Proposed PD - For Review

ISSUE DATE:
March 12, 2020

Re: Center Stage Planned Development
Keller, Texas

Concept Plan Changes

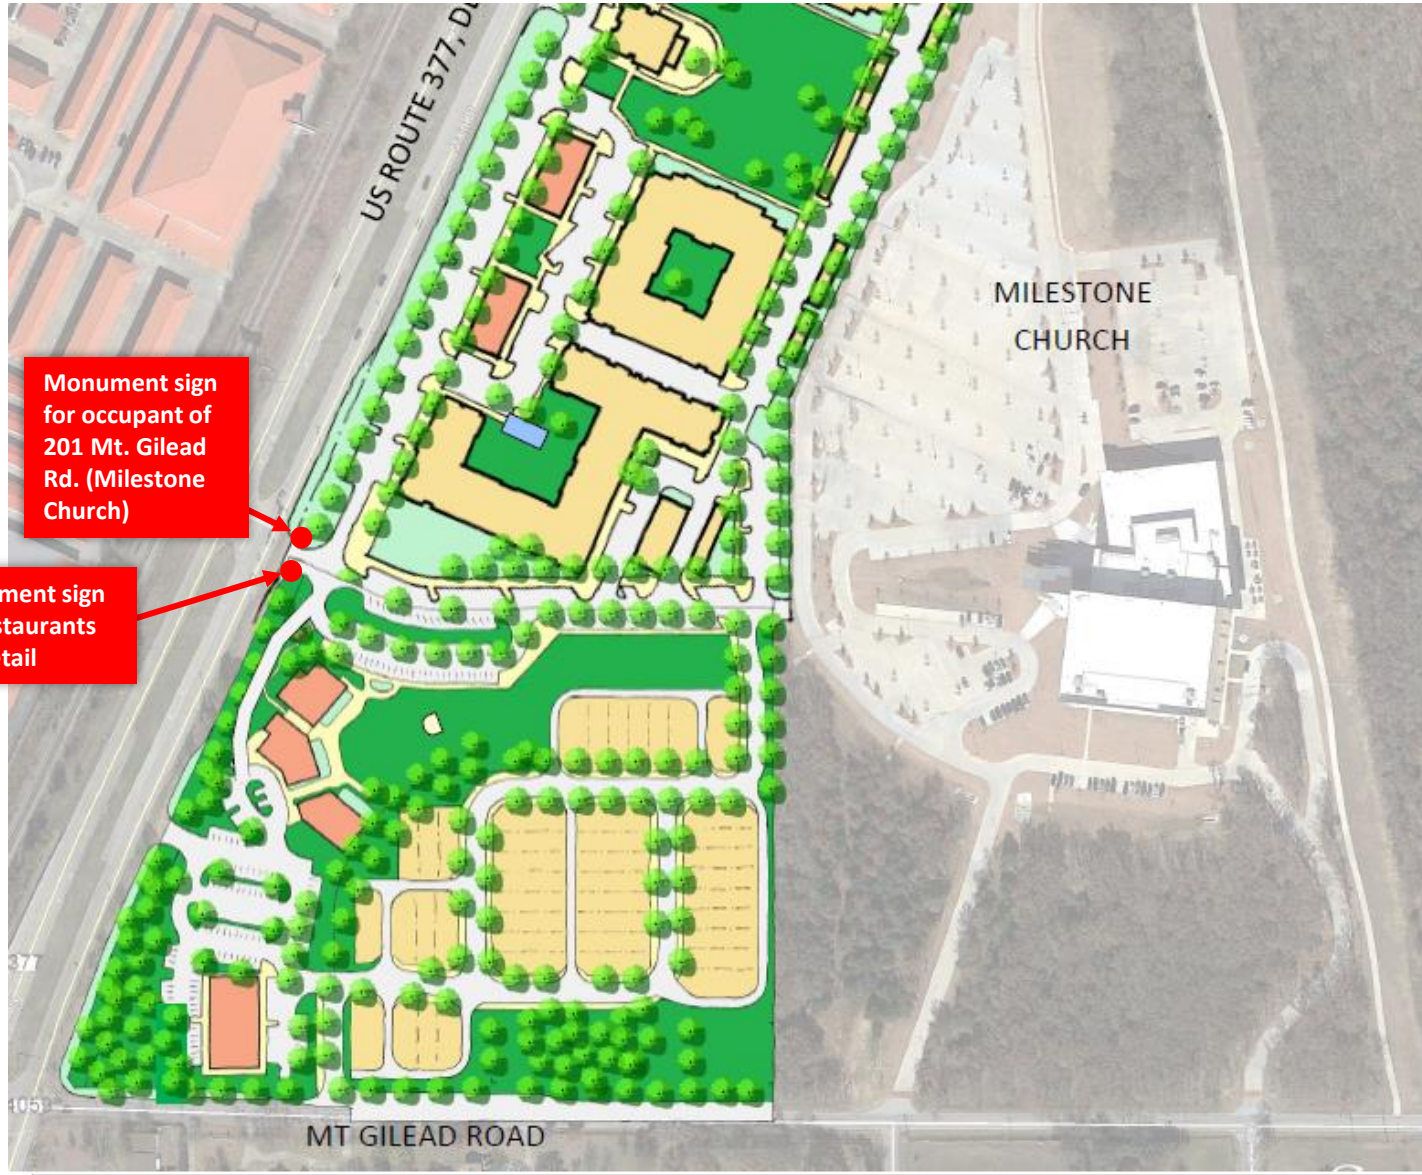
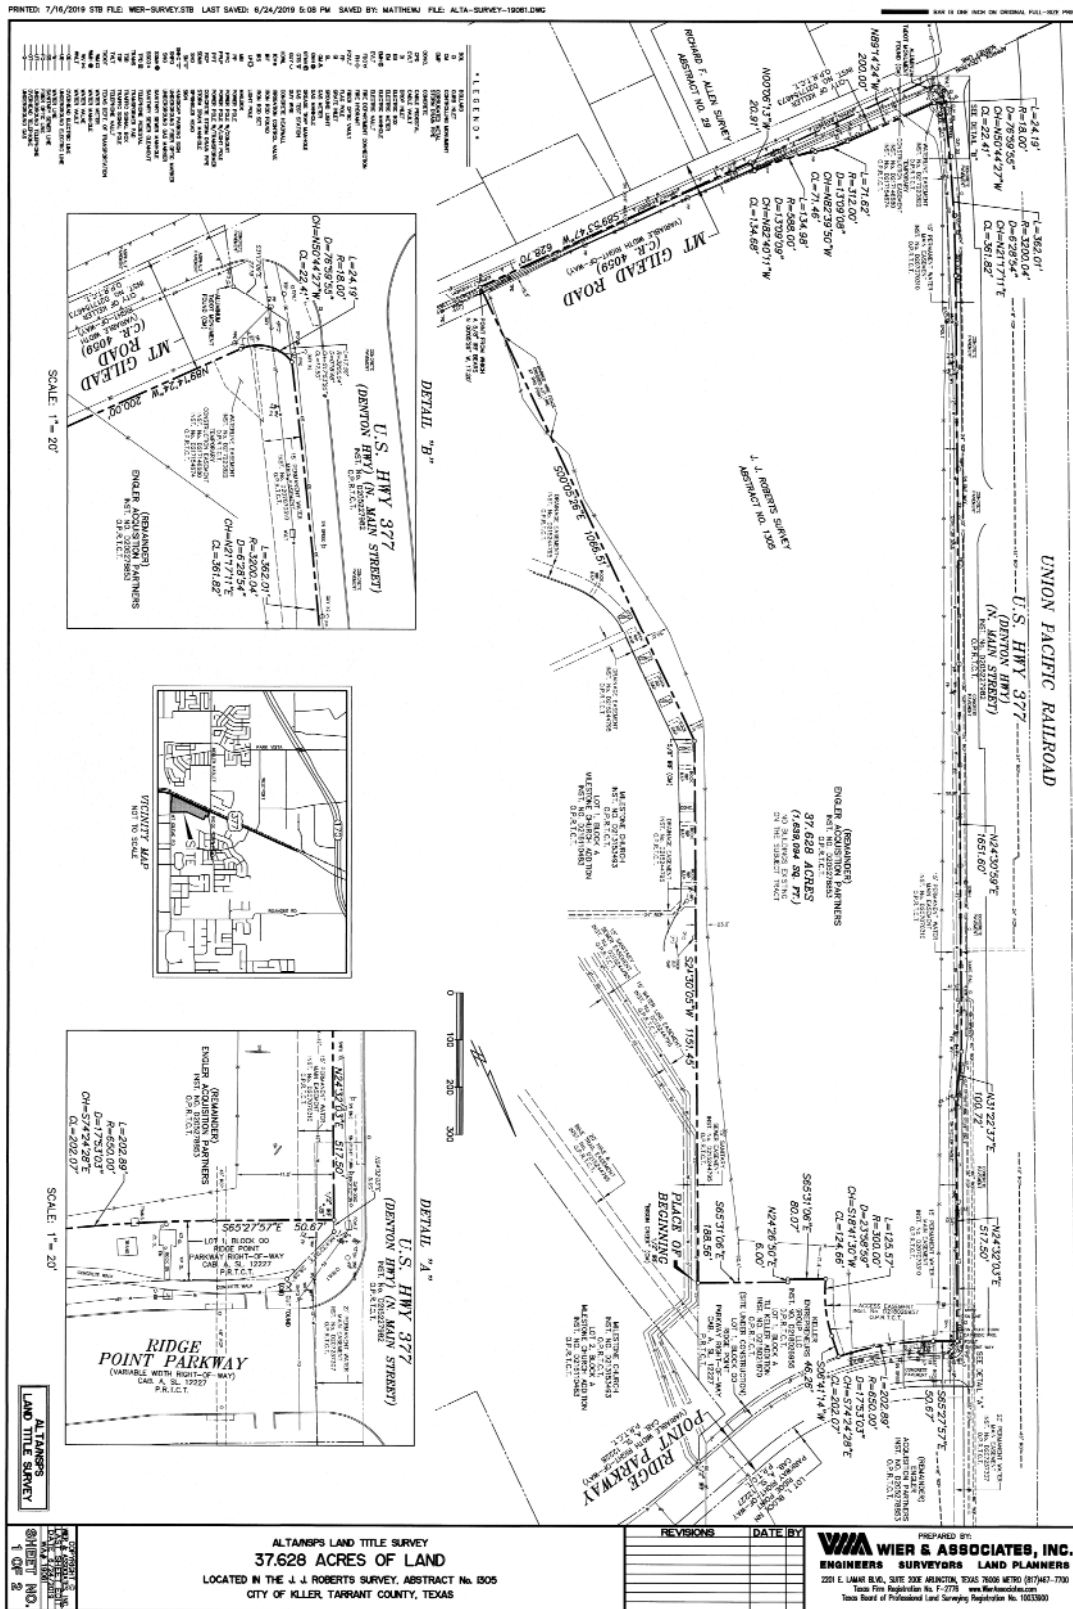
Added language to allow second monument sign at Driveway 1 (Figure 4.1) to include off-site monument signage (on each side of monument sign) for the occupant of the property located at 201 Mt. Gilead Road. Milestone Church has completed connection through Center Stage to 377 to alleviate traffic and needs a visual presence on 377.

Monument sign
for occupant of
201 Mt. Gilead
Rd. (Milestone
Church)

Monument sign
for restaurants
and retail
